REPORT ON FIRE FIGHTING SERVICES
IN THE
FALKLAND ISLANDS

FIRE PREVENTION INSPECTION REPORTS.

CONTENTS: FI GOVERNMENT DEPARTMENTS.

RECOMMENDED FIRE RESISTING
CONSTRUCTION OF DOORS

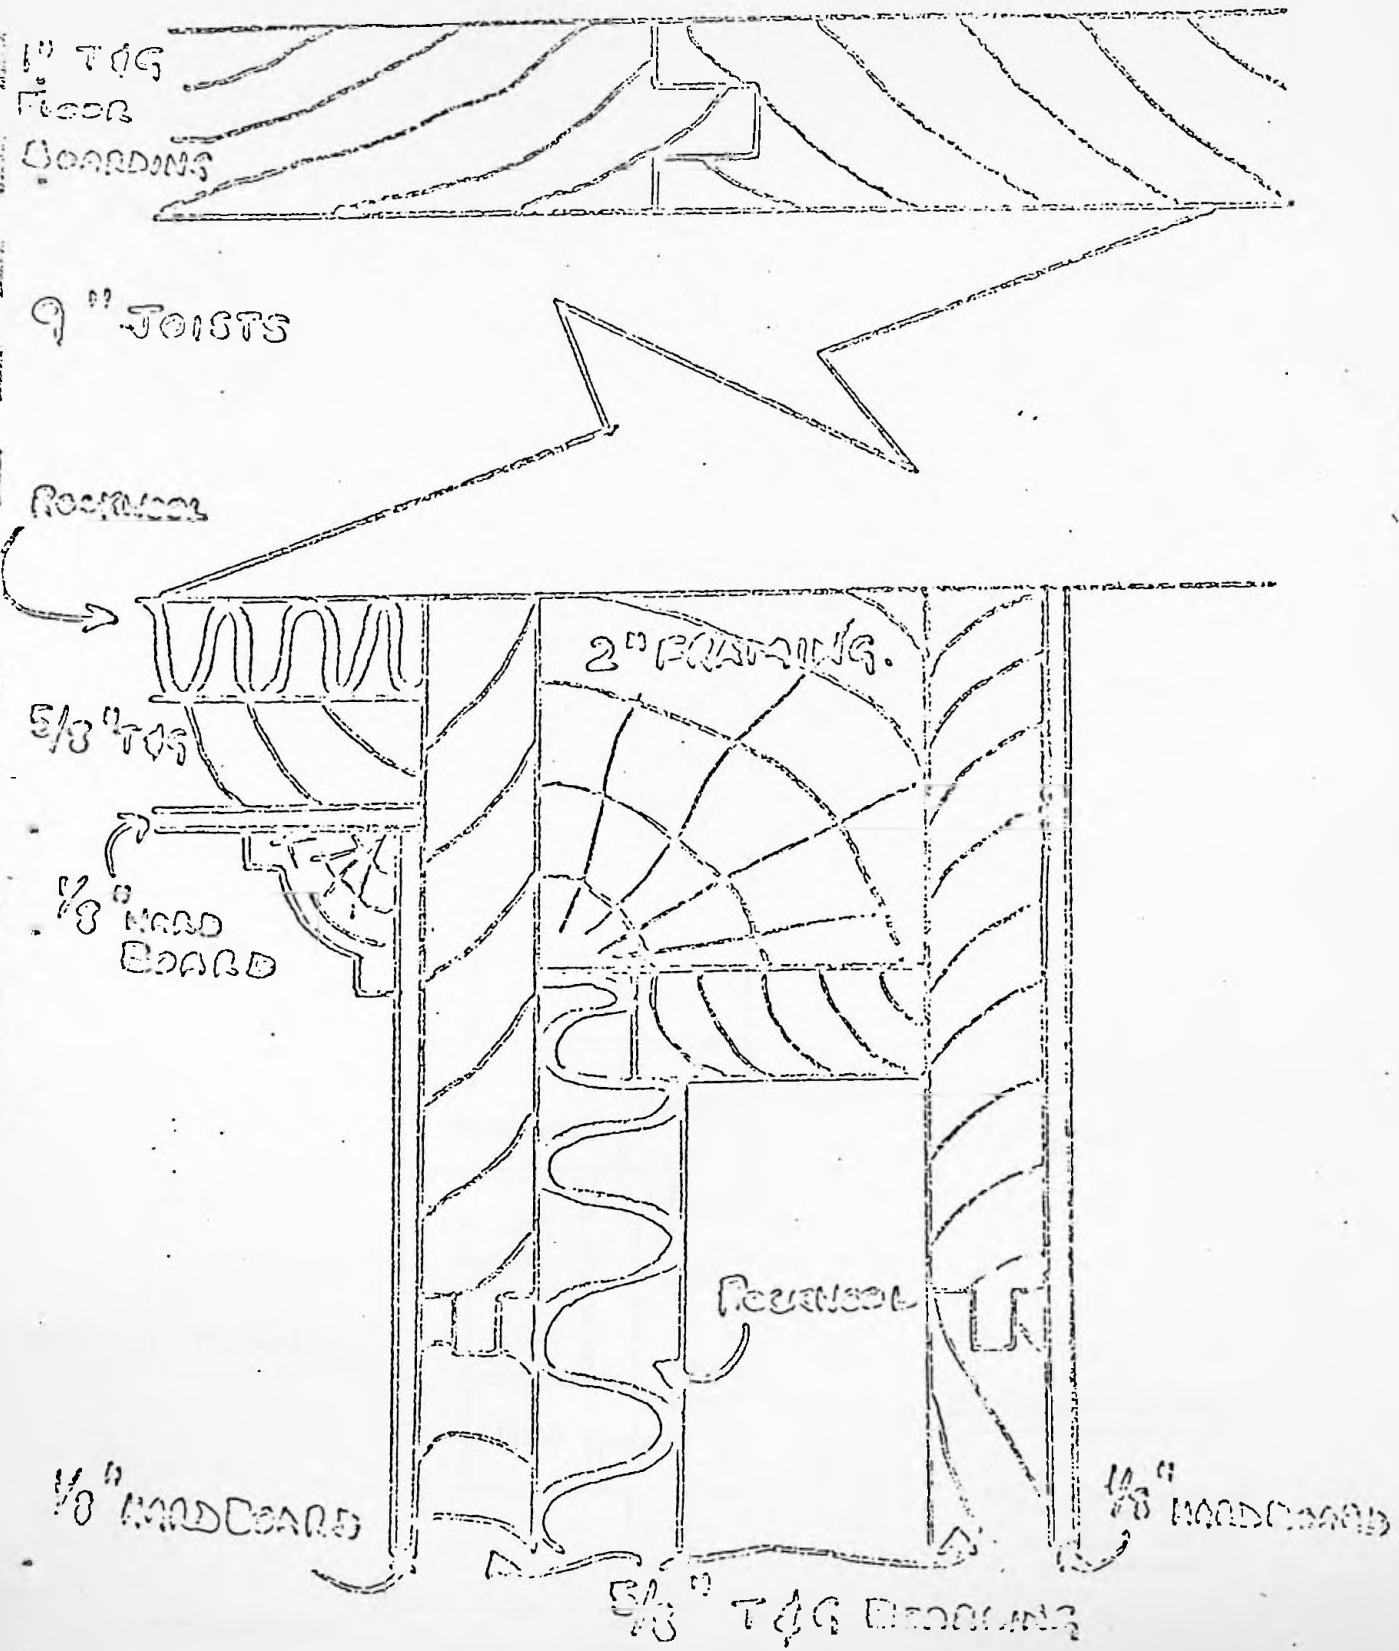
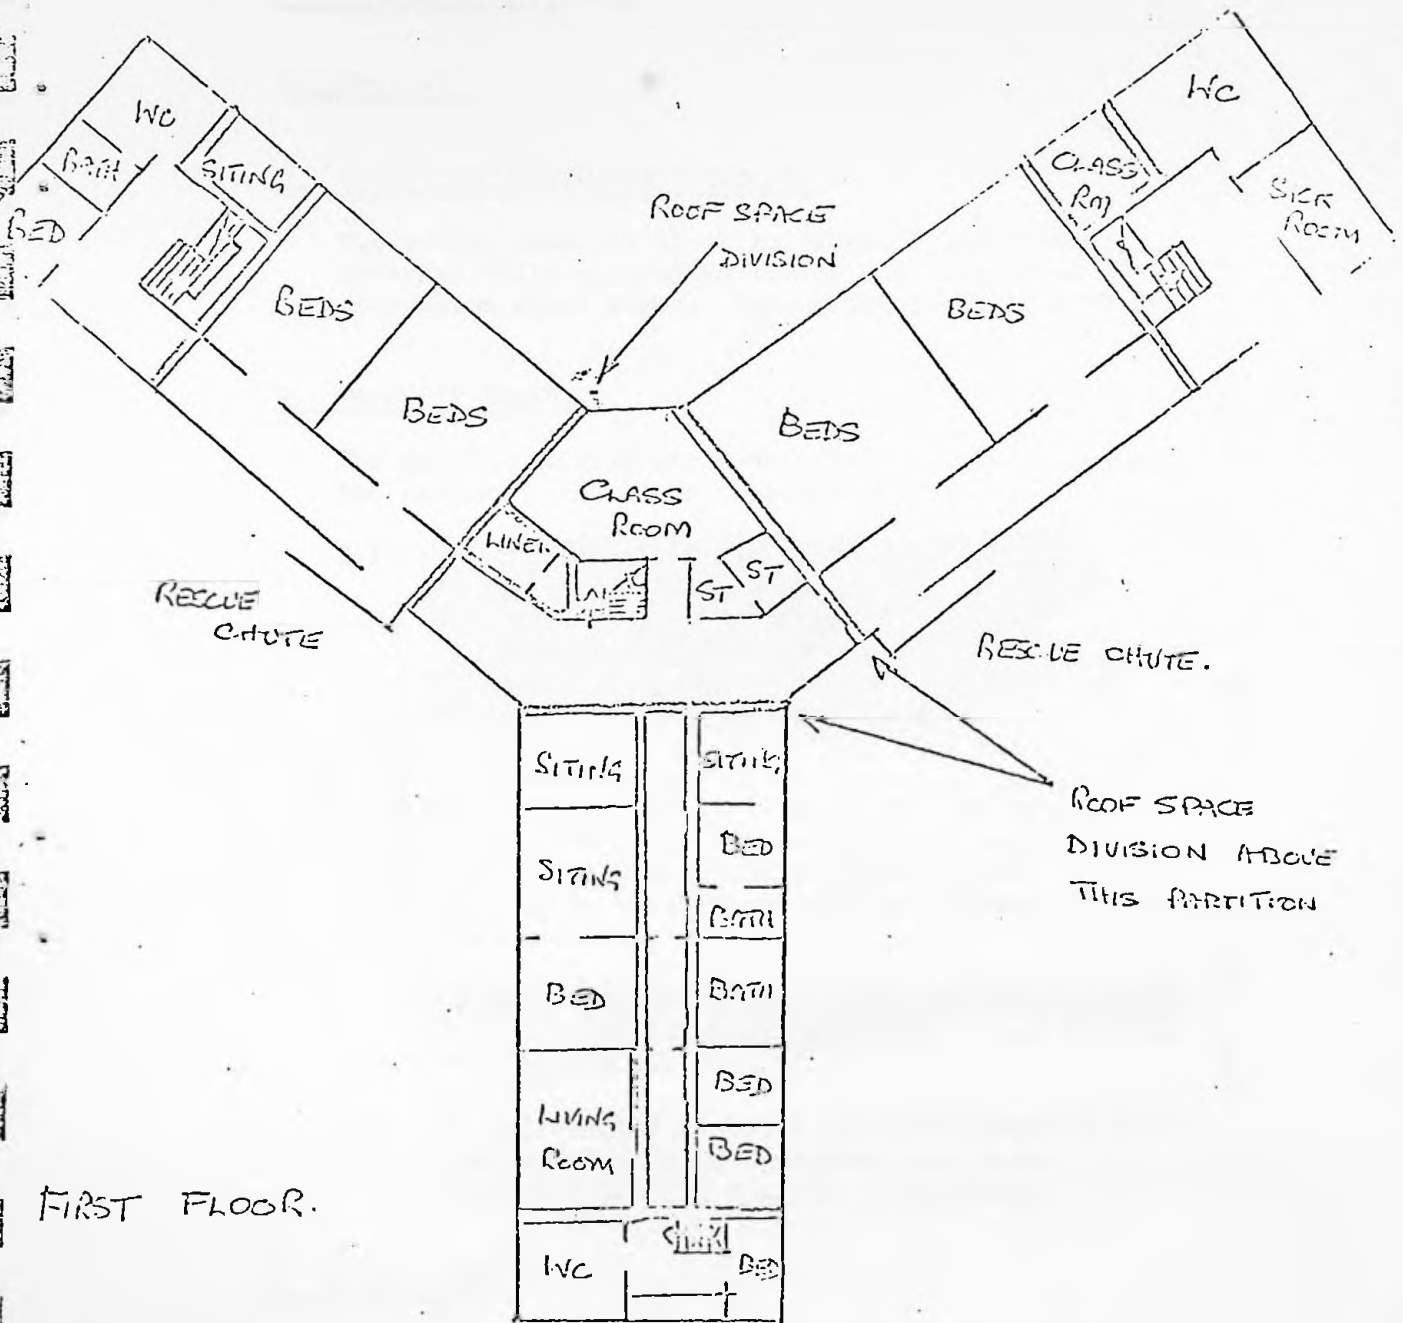
2.1.2. Partitions associated with the above doors to be fire resisting unless constructed in accordance with the attached sketch which details the general construction elements of the building and which will provide 30 minutes fire resistance.
